CITY OF KIRKLAND
Planning and Community Development Department
123 Fifth Avenue, Kirkland, WA 98033 425.587.3225
www.kirklandwa.gov

MEMORANDUM

To: Design Review Board
From: Jon Regala, Senior Planner
Date: September 8, 2014
File No.: DRV14-01332
Subject: EASTSIDE PREPARATORY SCHOOL EXPANSION – SCIENCE BUILDING & GYM
DESIGN RESPONSE CONFERENCE

WEST ELEVATION

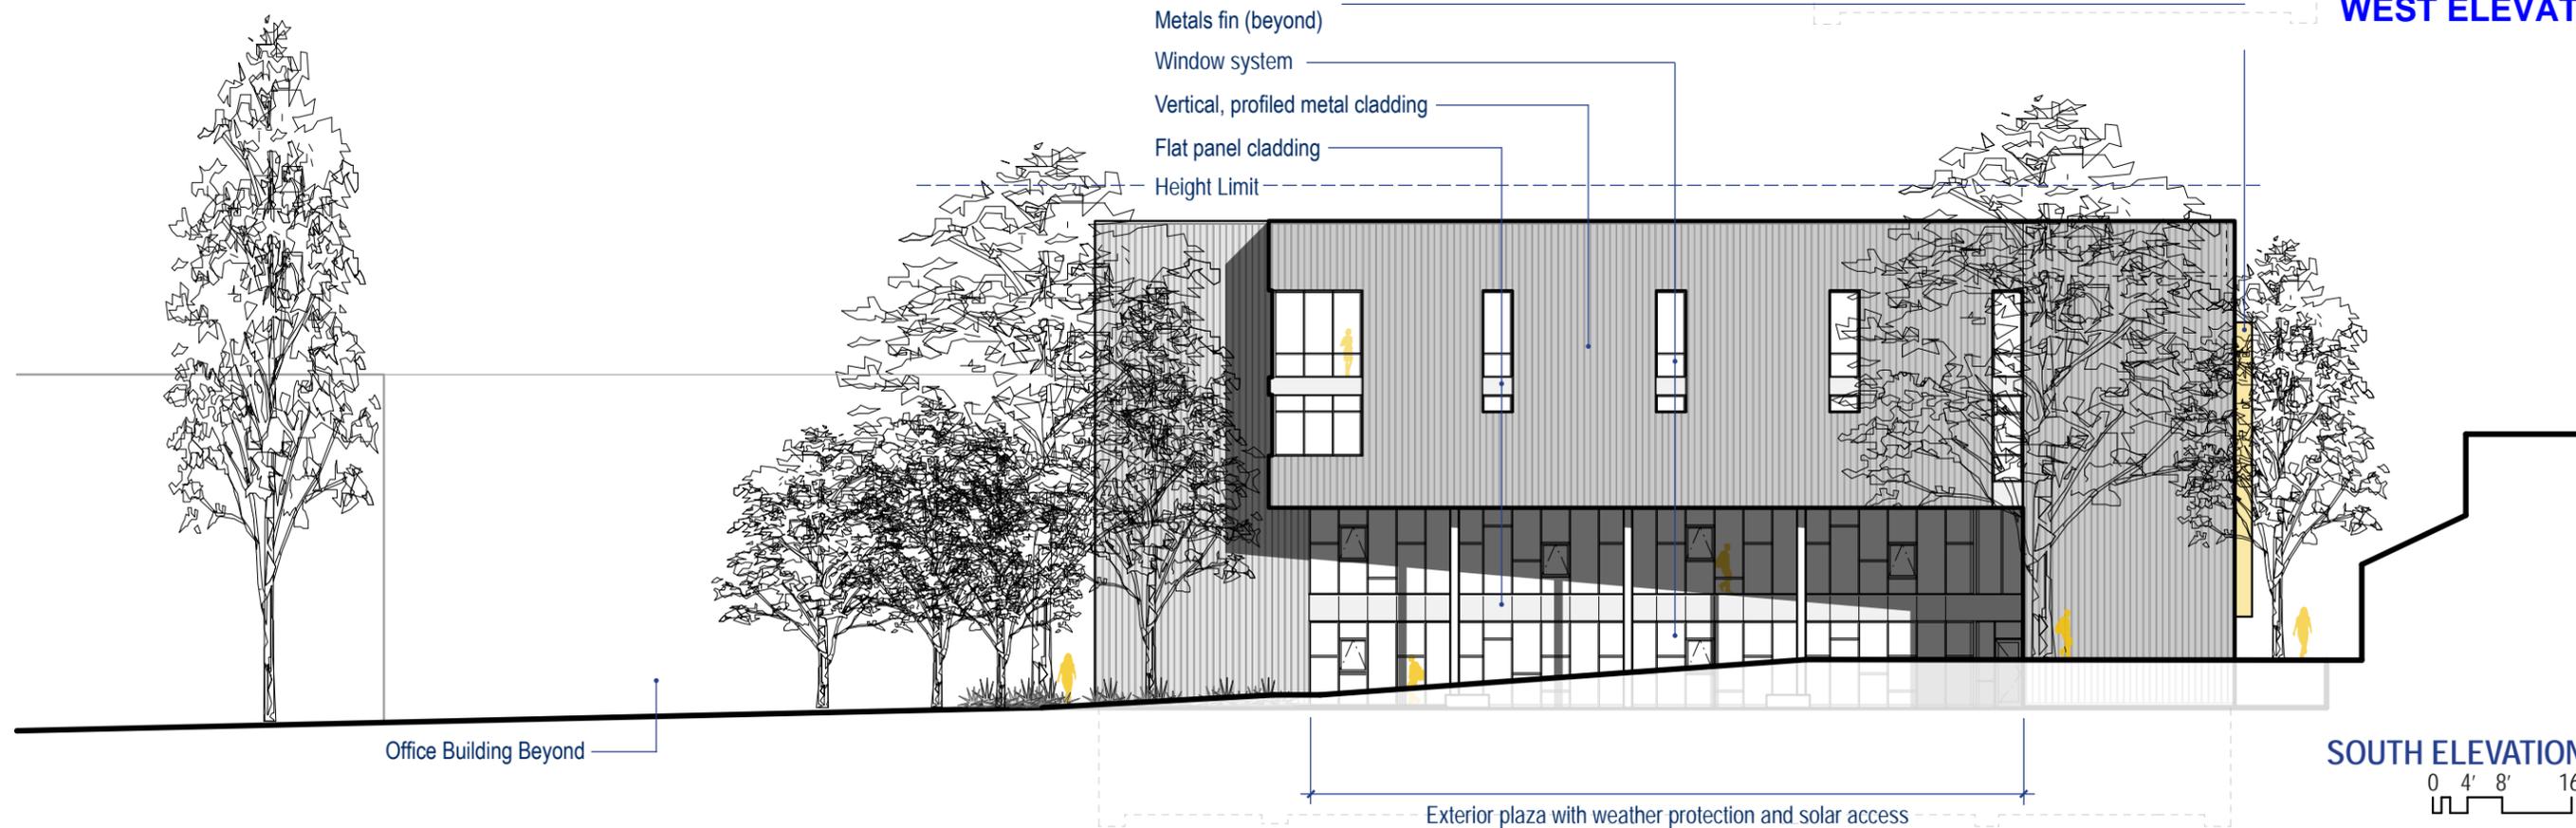
Staff finds that the west building elevation, which faces the play area (see also diagram above), and as it wraps around to the northwest and southwest, appears more imposing than the other facades. This is due to a lack of modulation, glazing, little change in materials/colors and lack of human scale features, resulting in portions of the facade appearing as a blank wall.

Given these concerns, there are a number of techniques which can be applied to this façade given its larger mass. One technique that can be used to help achieve horizontal definition and moderate the vertical scale of buildings is to **clearly identify a buildings' top, middle, and bottom**. To better define a **buildings' top**, articulation of the roof form using strong eave lines, cornice, and/or parapet treatments can be used. When viewing the roof plan for the project, two areas have been identified for mechanical equipment (see Attachment 6, page 18). Given this and the building being **4' below height** limit, there may be flexibility in varying the roof form. To establish a stronger base, pedestrian scale elements using materials such as concrete stone, masonry, stucco, etc. can perhaps be incorporated at the ground level.

- Determine if the building mass added at the top of the bay element along the south façade is acceptable.
- Review the west façade (facing the play area) and as it wraps to the northwest and southwest. Provide feedback in terms of addressing building scaling, articulation, and blank wall treatment.
- Are changes needed to the building when viewed from the key vantages: entrance at NE 38th Place and Northrup Way? If so, what additional details are needed from the applicant?
